Re: **Addendums and Dividers for Approved Work Plan dated 28 July 2000**  
**Project No. 805169**

### Work Plan – Removal of Asbestos and Vermiculite at the Libby Asbestos Site

**ADDENDUM NO. 2**  
**Work Plan – Removal of Asbestos and Vermiculite**  
**at the Export Plant, Libby Asbestos Site**  
**28 July 2000**

**ADDENDUM NO. 6**  
**Work Plan - Removal of Asbestos and Vermiculite**  
**at the Export Plant, Libby Asbestos Site**  
**06 September 2000**

**Figure 4-1**

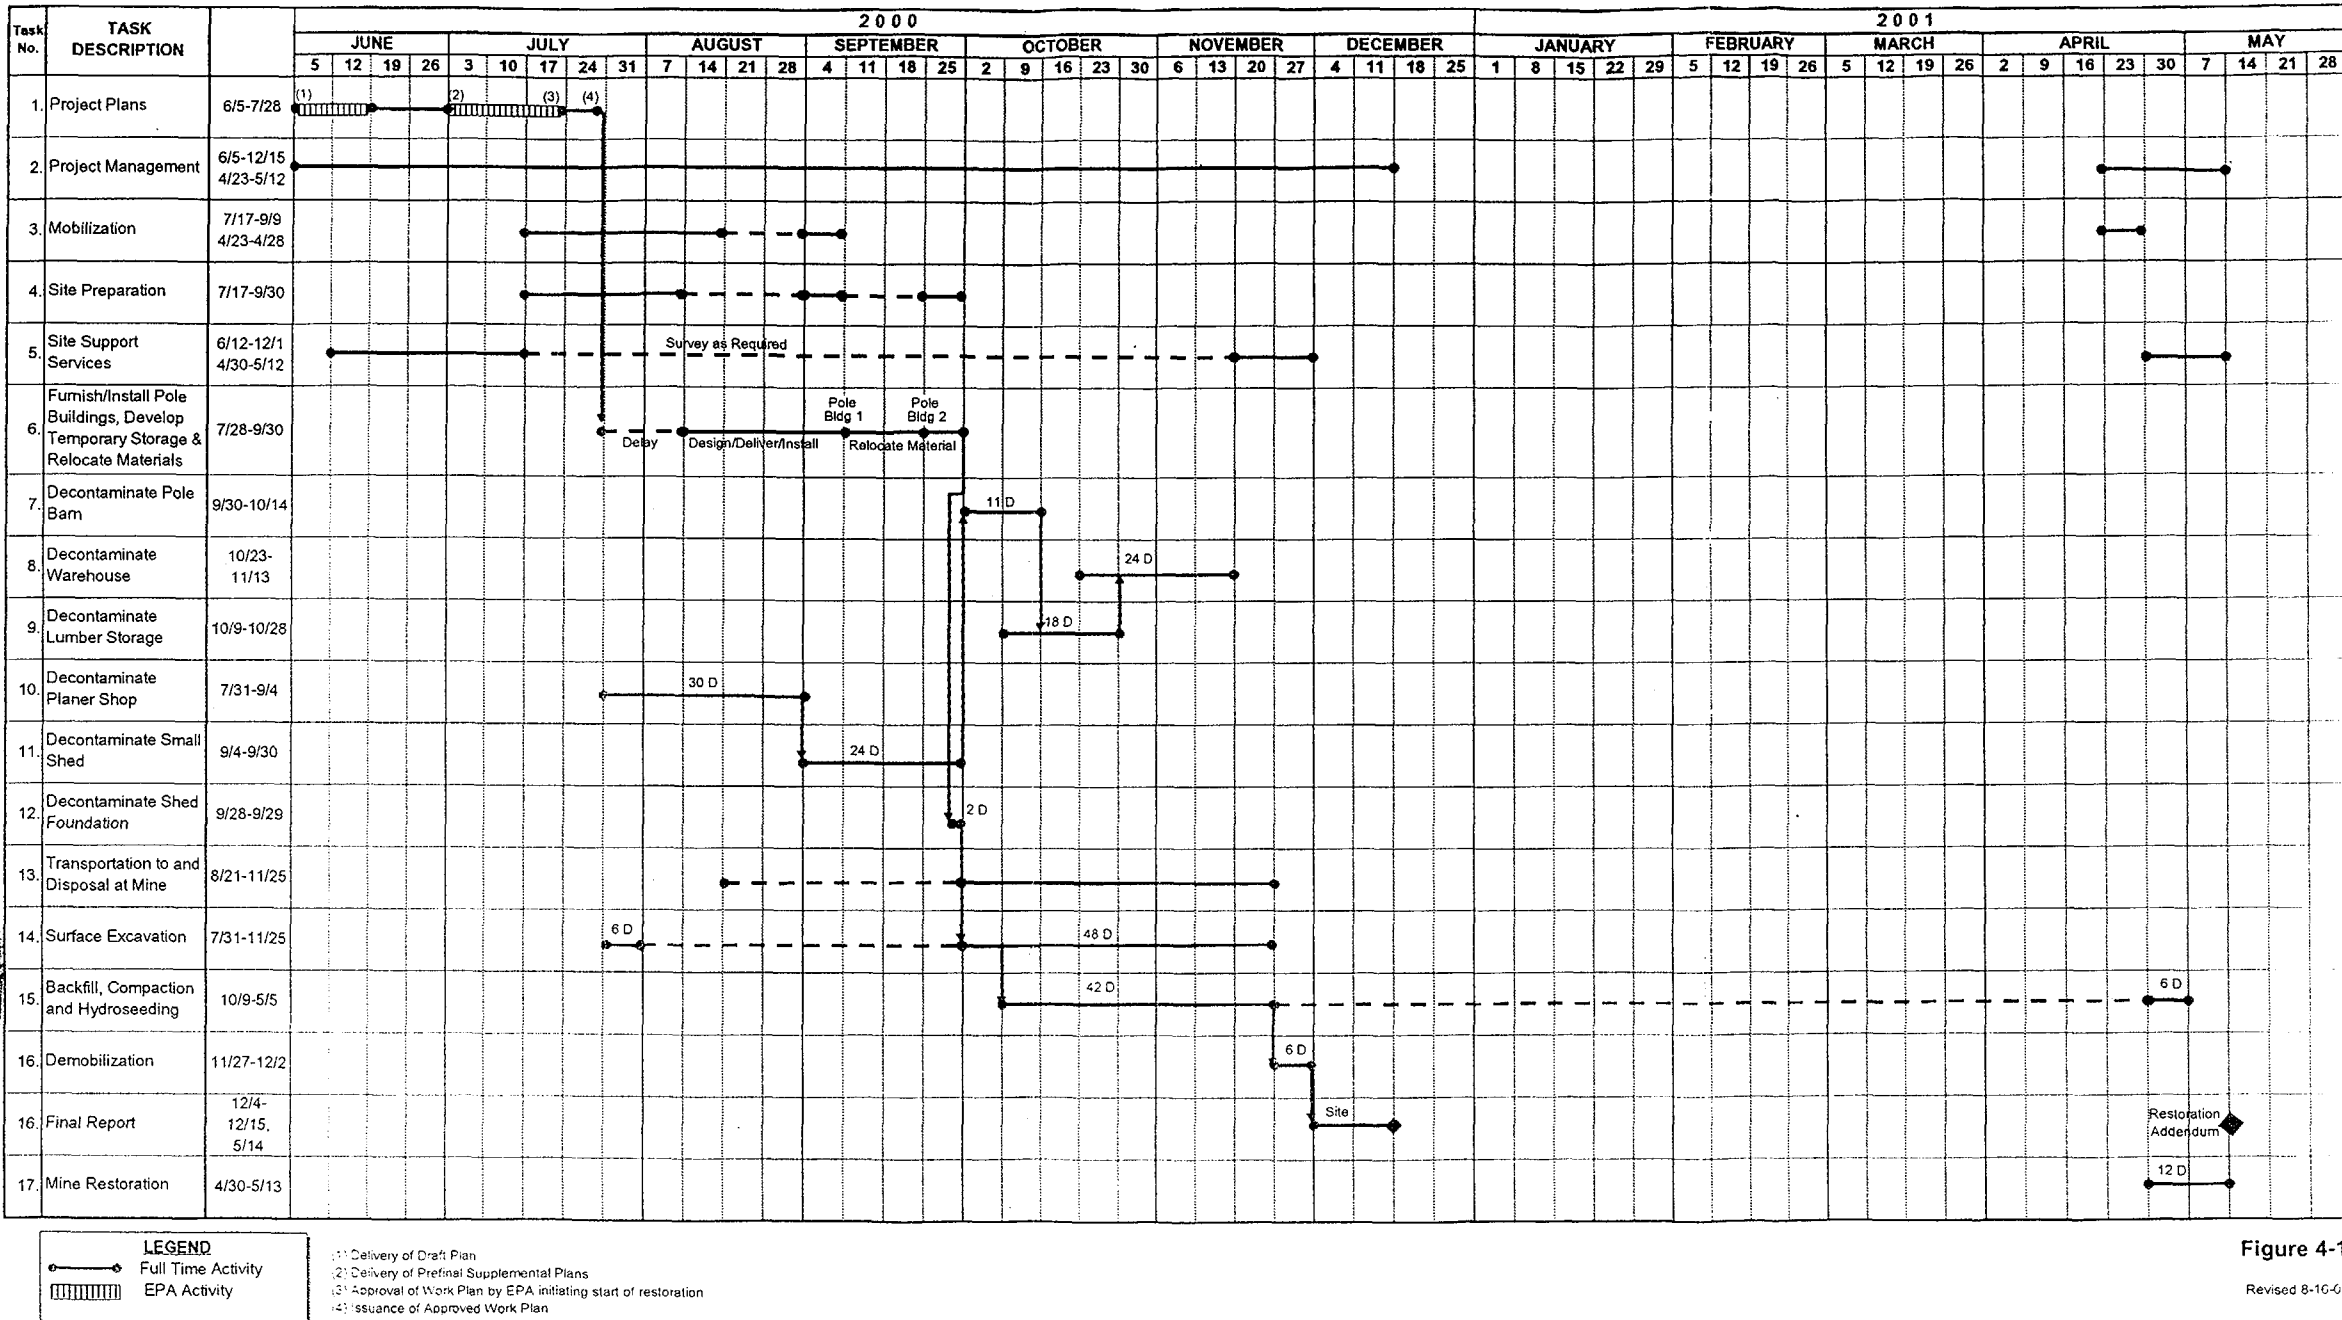
This addendum to the 28 July 2000 Work Plan for the removal of asbestos and vermiculite at the Libby Asbestos Site is issued to amend the implementation schedule and sequence of performing activities. See Section 4.0 and the schedule, Figure 4.1.

To offset these delays, both the planer building and small shed will be cleaned under controlled conditions prior to September 25. This is reflected in the revised schedule (attached).

However, the installation of the decon pad, site enclosure restriction fencing, pole building cleaning and soil excavation is postponed, and these control the remaining schedule. Completion of surface excavation and transportation to the mine is now forecasted for November 25, 2000. This delay has moved activities into the winter season at the location.

The attached revised schedule reflects restoration upon return of favorable seasonal conditions in April and completion on May 12, 2001. Actual work is performed in the allotted 20 weeks, however, a winter shutdown is required and shown in the schedule.

**Figure J-1. Site Locations**

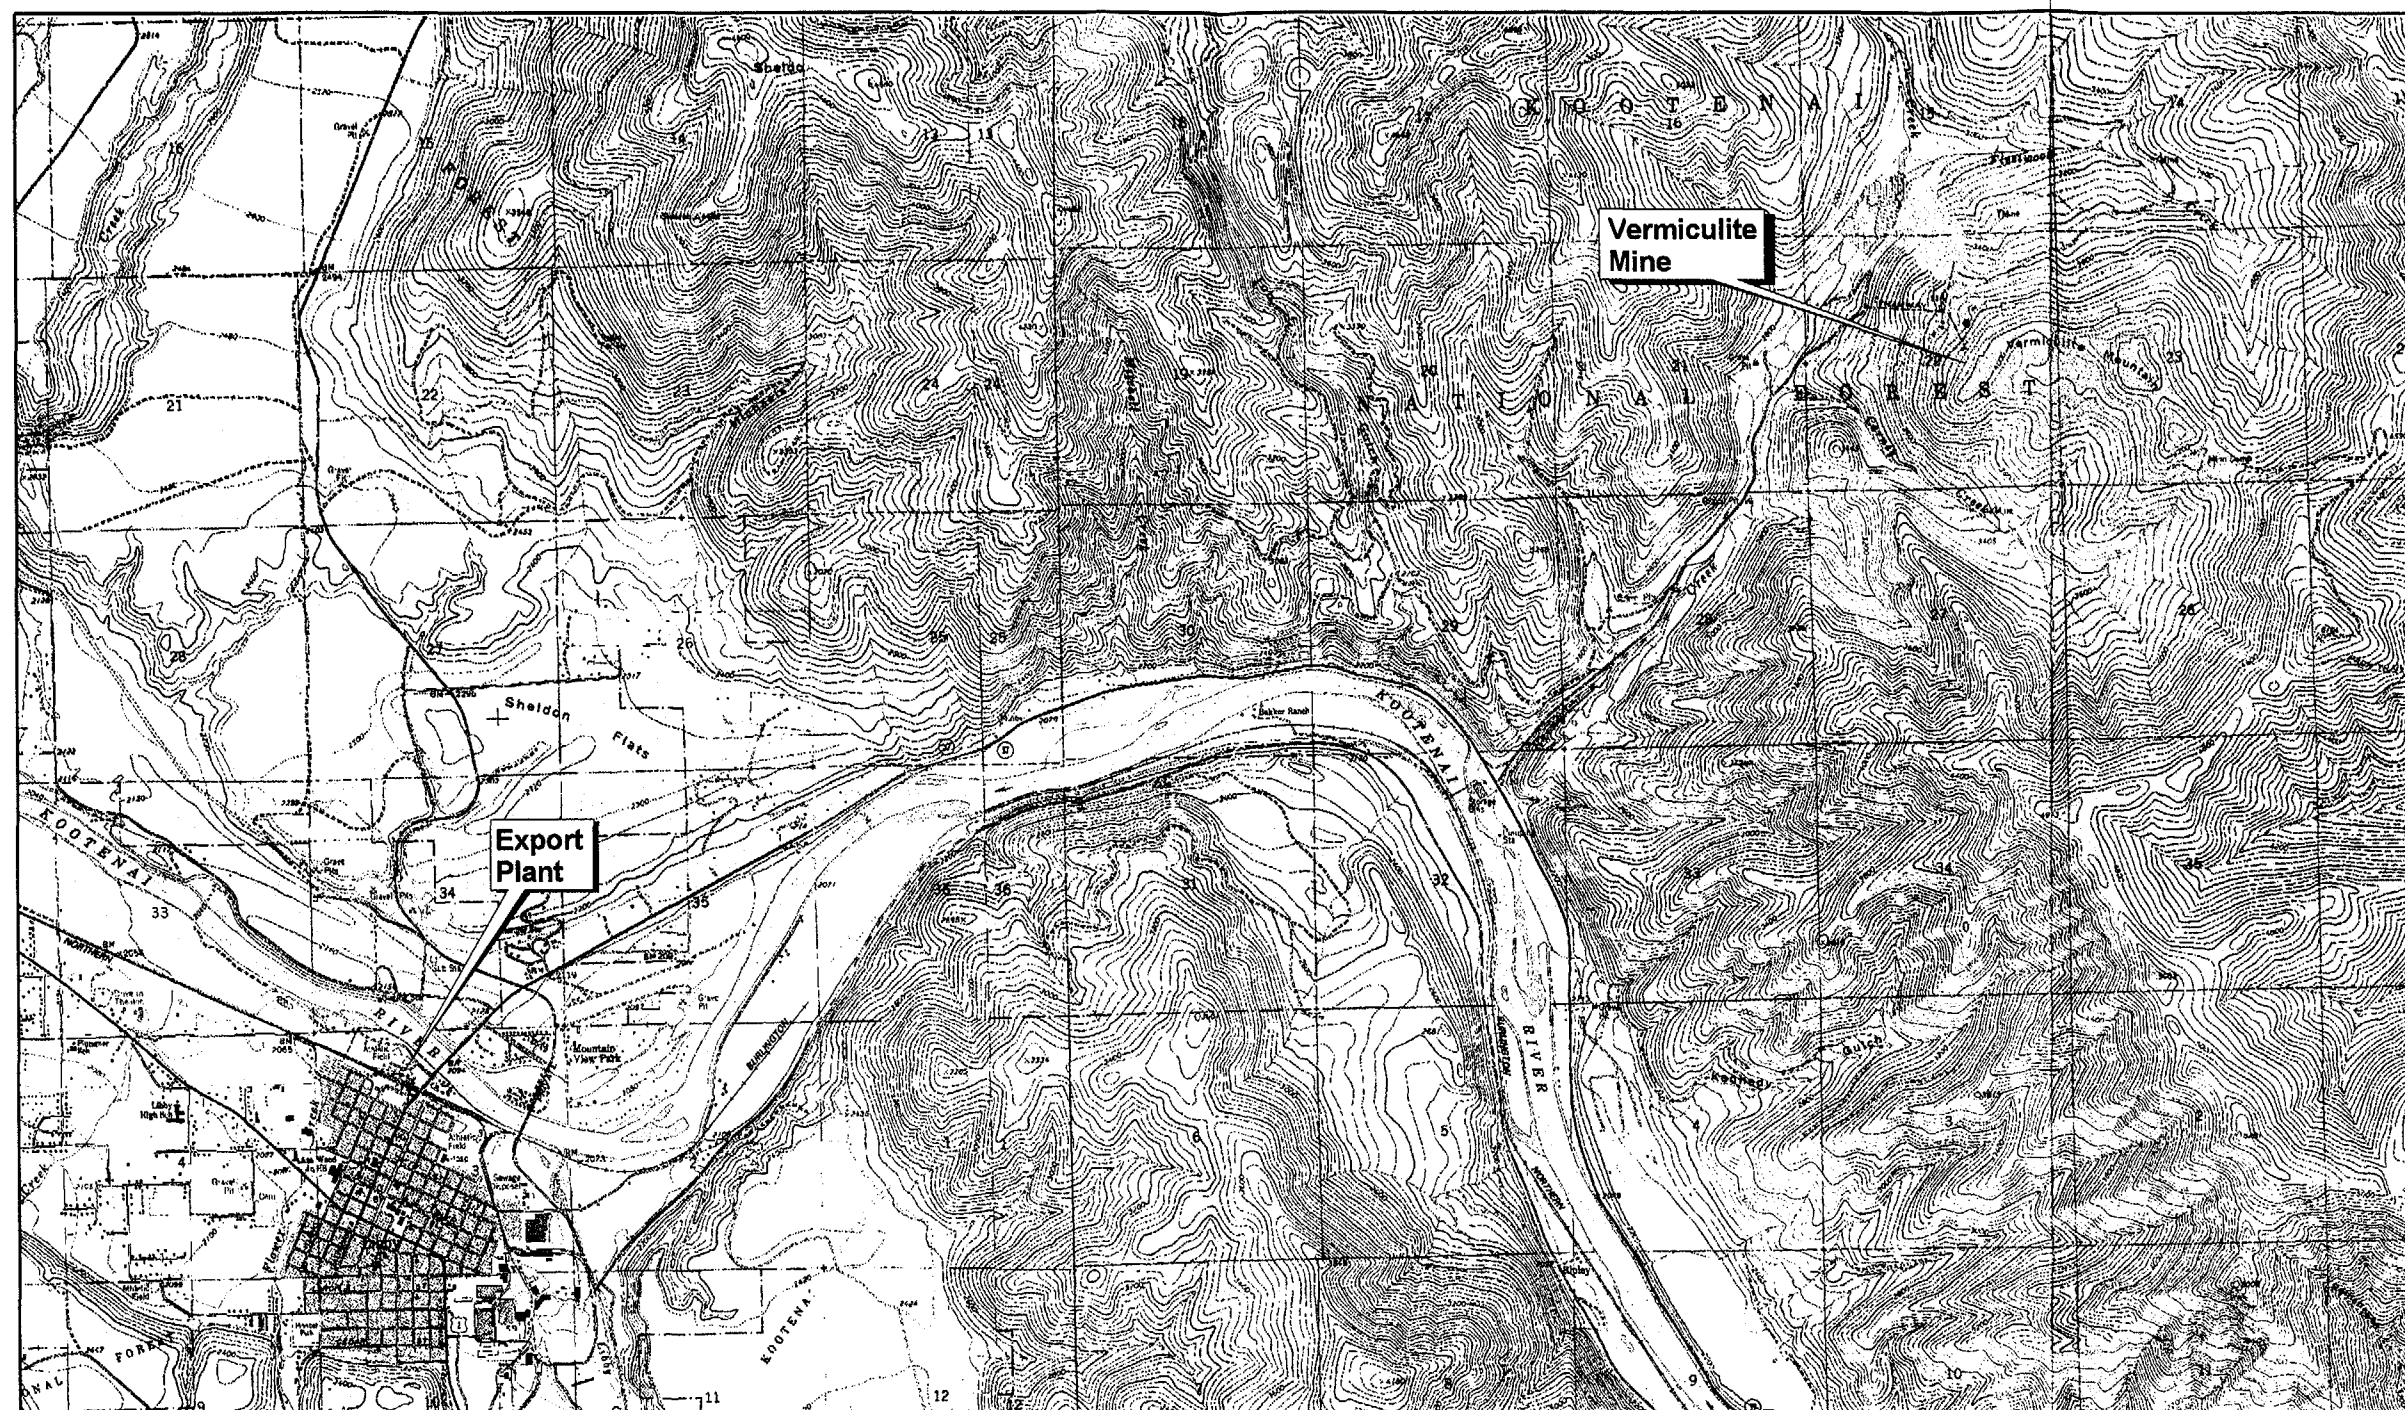
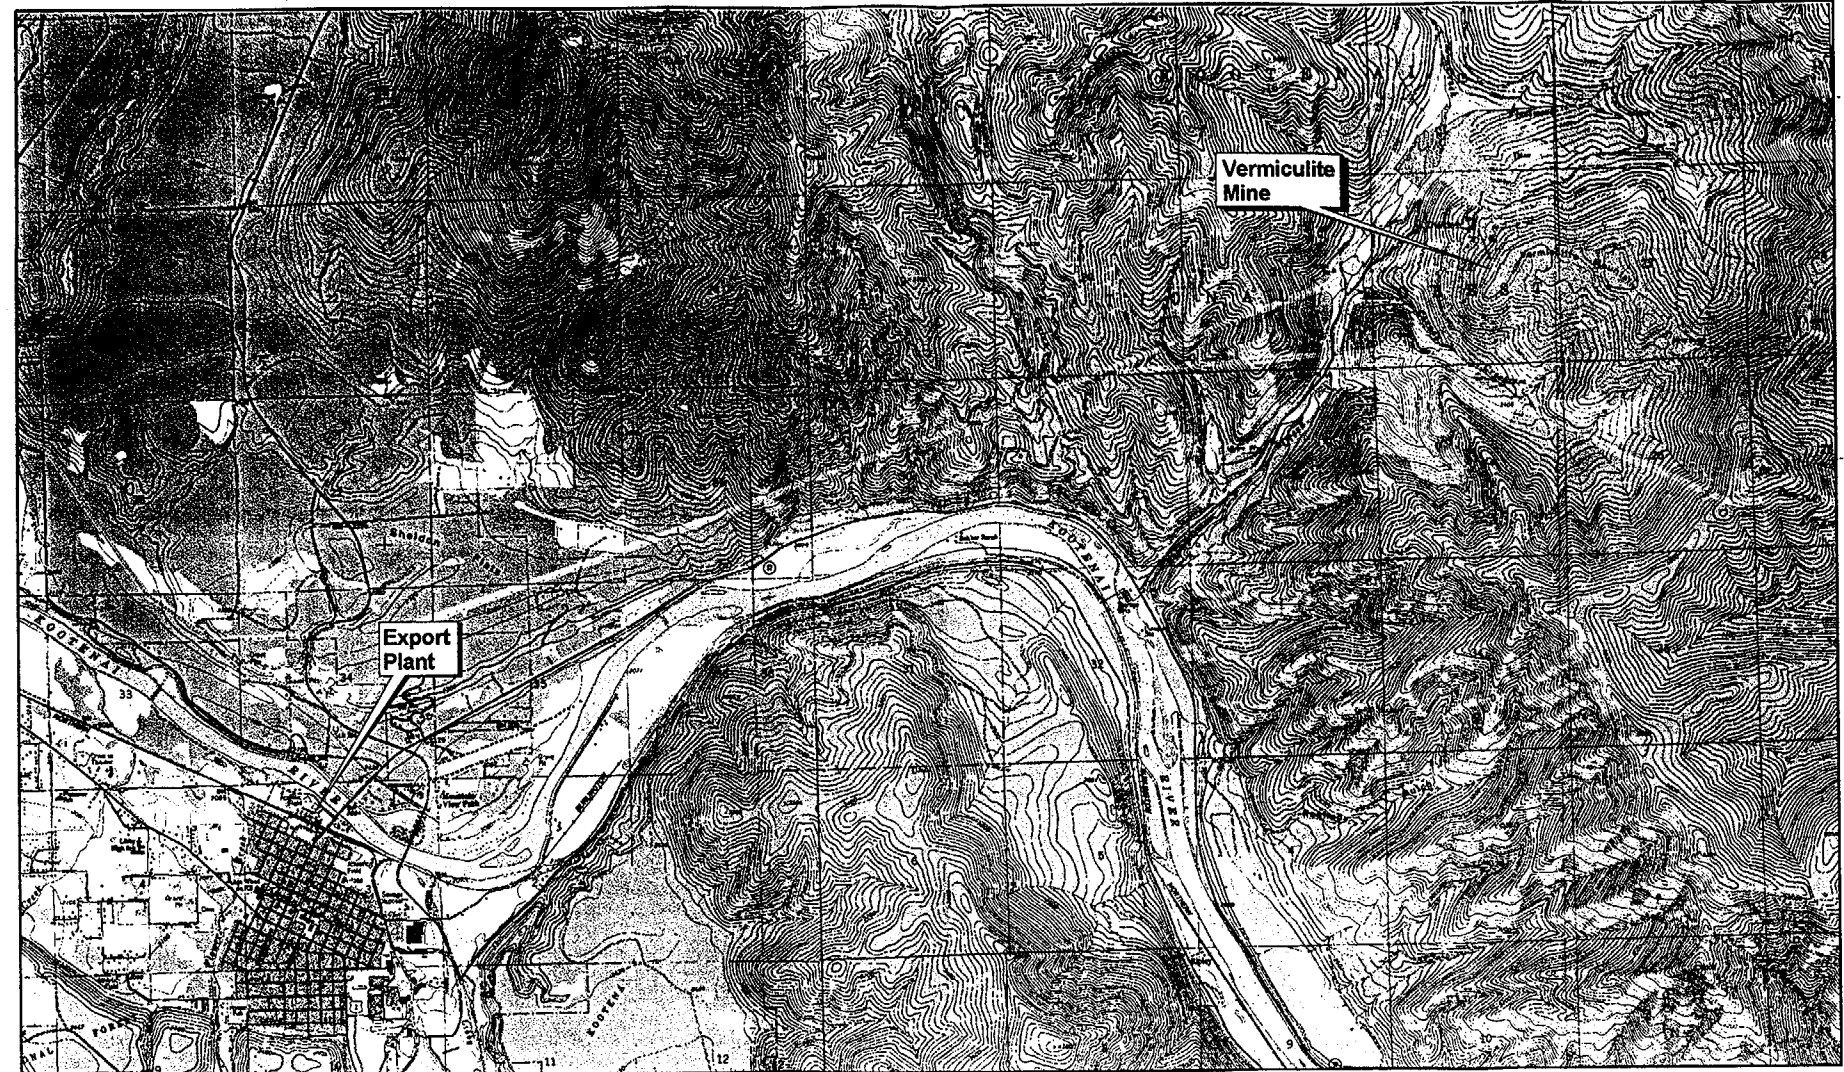
The vermiculite mine is located approximately 8 miles to the north and east of the Export Plant as shown on Figure J-1. Since mining operations ceased in 1990 the mine property was reclaimed by Grace and subsequently sold to Kootenai Development Company. Previous restoration activities included regrading operations and planting of native vegetation.
